**TOWN OF HERNDON, VIRGINIA
PLANNING COMMISSION PUBLIC HEARING AGENDA
MAY 23, 2022
HERNDON COUNCIL CHAMBERS BUILDING
765 LYNN STREET
7:00 P.M.**

8. **DEVELOPMENT PLAN – DP #19-01, 593 Herndon Parkway, Parkview**, a development plan in the Planned Development-Transit Oriented Core zoning district with proffered conditions to allow the redevelopment of the site with mixed office, retail, and multi-family residential uses. Fairfax County Tax Map Reference Number: 0164-10-0007C. Agents: Greg Riegle and Lori Greenlief, McGuireWoods, LLP. Applicant/Property Owner: Parkview Executive Center, Joint Venture, RLLP.

MEMORANDUM

Subject: Staff Report Addendum, DP#19-01

ILLUSTRATIVE GROUND LEVEL PLAN

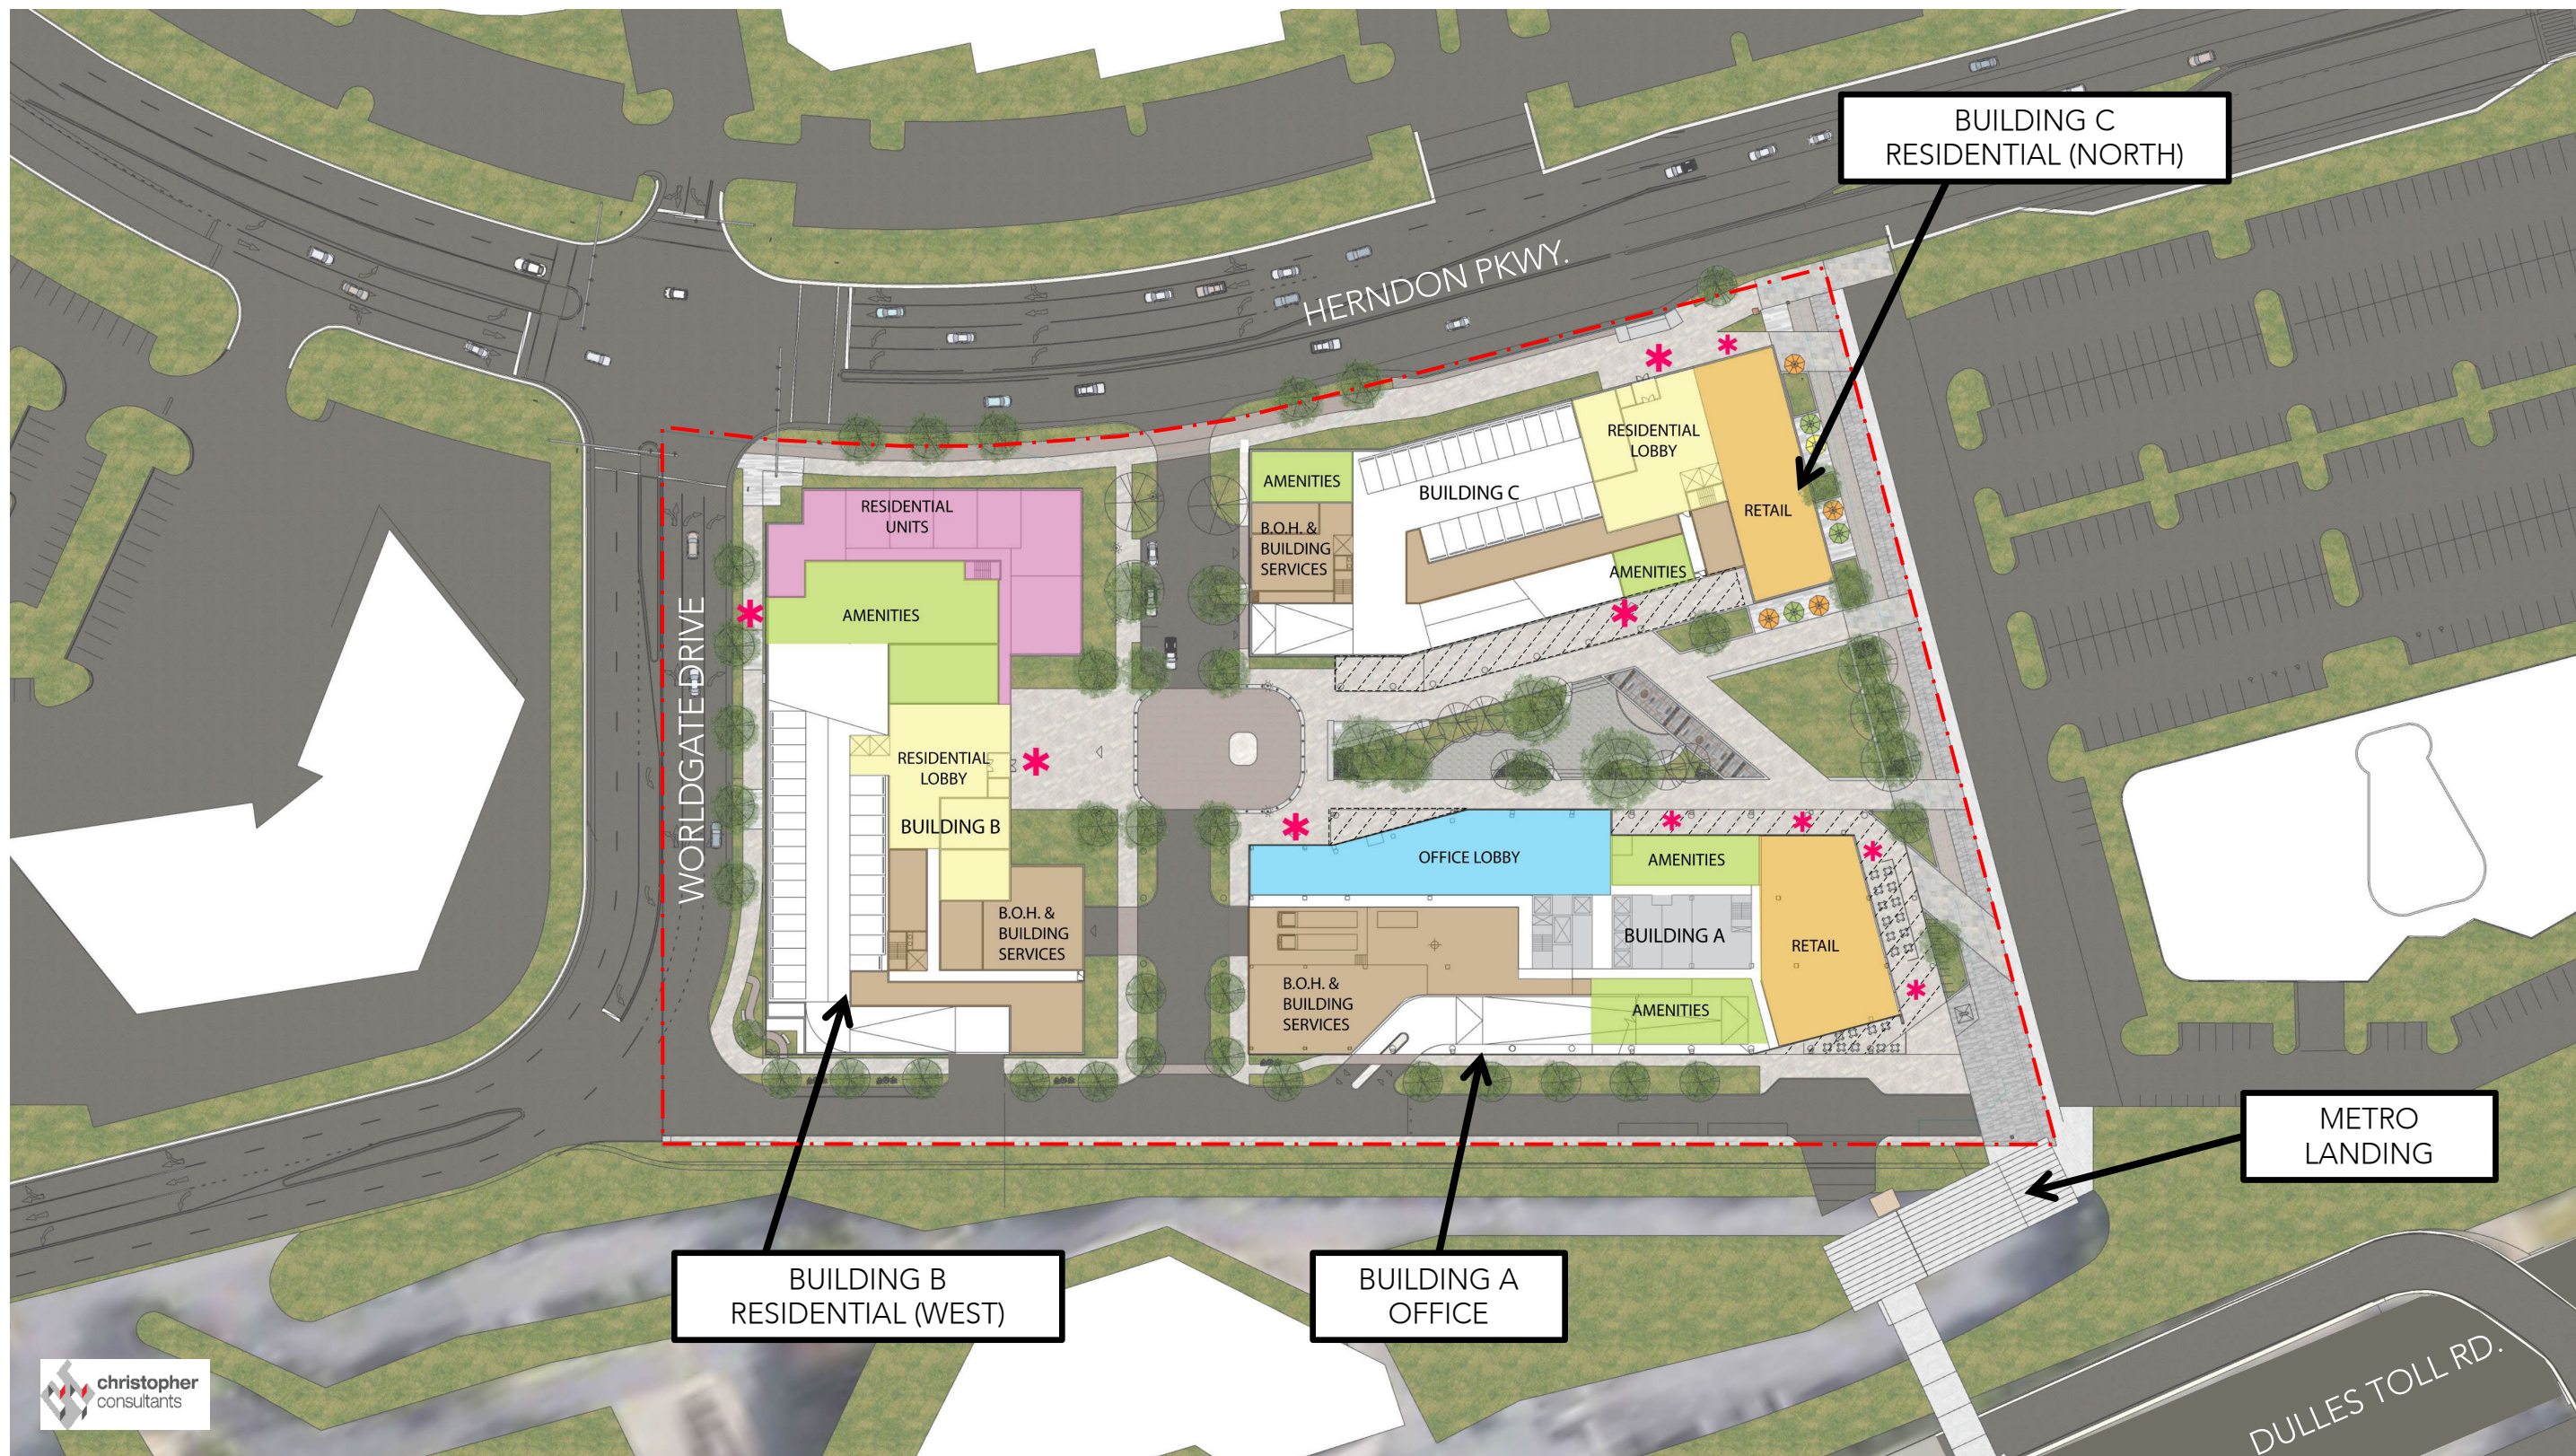
The applicant presented perspective renderings of the building and open space design to the ARB for the minimum FAR option, however those drawings have not yet been included in the Development Plan set. To help ensure the intended vibrancy of the urban environment, a stronger commitment to those drawings in the proffers and plan set would be necessary. Those drawings presented to the ARB are provided in this memo as Attachment #1.

In evaluating the mix of uses as experienced at ground level, staff generated an exhibit that should help to clarify the location of activated spaces and non-activated spaces along frontage. That exhibit is provided as Attachment #2. It shows that approximately 60% of all frontages are activated with either retail/restaurant, residential units, lobbies, and amenity space, which may include shared office spaces and fitness rooms. This includes the Promenade frontage that is shown at 100% activated as proffered (Proffer #10). The Herndon Parkway frontage is similarly comprised of activated ground floor uses however both the Worldgate Drive frontage and the frontage along the south road are predominated by garage and other back of house ground floor uses.

It also remains important to be thoughtful and deliberate in how the non-activated spaces are designed, particularly along Worldgate Drive which will be a public road. The pedestrian experience along garages and back-of-house facades hinges upon the design of the building facades, as well as the abutting streetscape, at those locations. This was discussed by the ARB during their work sessions, and during the Planning Commission work session. Continued refinement of the design, to include varied materials, textures, wall plane breaks, decorative or artistic features, and ample landscaping along both activated and non-activated frontages, is necessary to ensure the quality of urban design anticipated in the HTOC. While the details of this matter can be addressed during the formal ARB review process, following site plan approval, staff believes more explicit commitment to providing a higher level of design along frontage would strengthen the ability of this case to achieve the objective of the Urban Design and Architectural Guidelines for the Herndon Transit-Oriented Core.
